RS-RS, and RS-MS LOS Multihop Path Loss Model

IEEE C802.16j-06/064

Base Document: C80216j-06_040:” Multi-hop System Evaluation Methodology (Channel Model and Performance Metric)”

To further clarify the LOS path model for RS-RS and RS-MS with a comparison to WINNER model

RS & MS below rooftop and on same street (2)

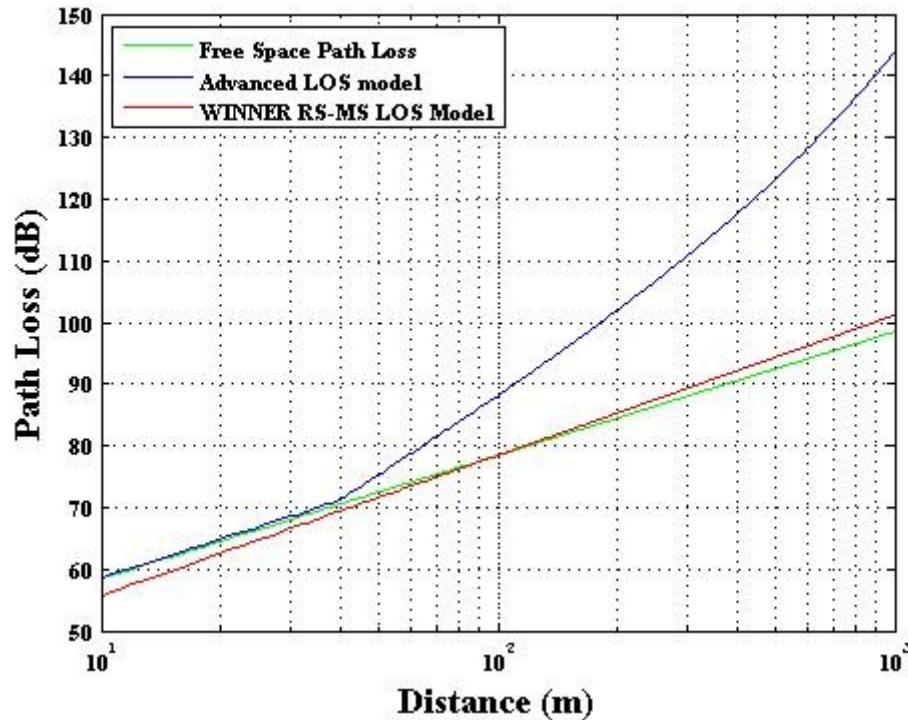
- The plots show a comparison of the WINNER path loss model and the advanced LOS model.
- The WINNER model is essentially the same as the free space path loss.
- The advanced LOS model is very different from free space loss due to the breakpoint and the visibility factor. The model is derived from measurements reported in [3]. For the case shown:

- Proposed WINNER model is essentially the same as free space path loss
 - Not consistent with published measured results, which suggest a two-slope model with a breakpoint
- Recommend advanced LOS model [4]
 - Includes effect of traffic through ‘effective road height’
 - Includes decreasing LOS probability with distance through an exponential visibility factor
